## Part Change Notice

**Company:** KYCON, Inc.  
305 Digital Dr.  
Morgan Hill, CA 95037  
USA  
408-494-0330

**Re: KUSBX-SMT-CS2-B30TR**

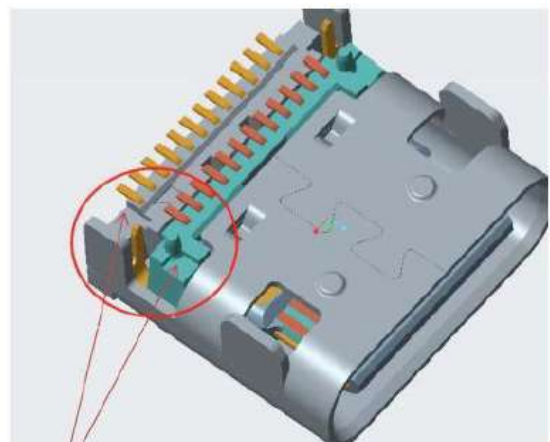
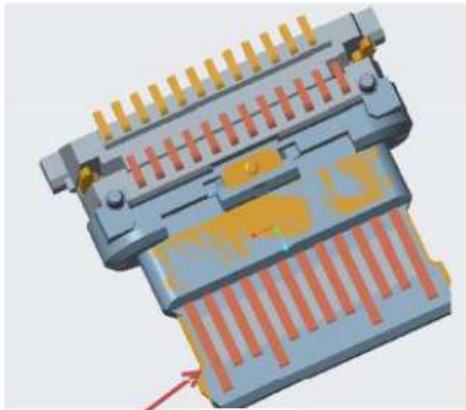
No undercut

Undercut added

Undercut was added to help molding process and prevent defects.

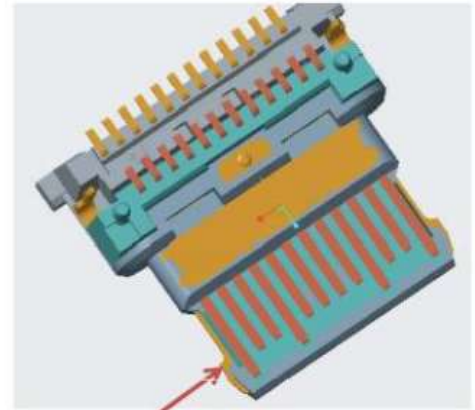
Old  
Grounding plate thickness 0.20mm

New  
Grounding plate thickness 0.15mm

Grounding plate thickness was modified to help increase the thickness of the molding material.
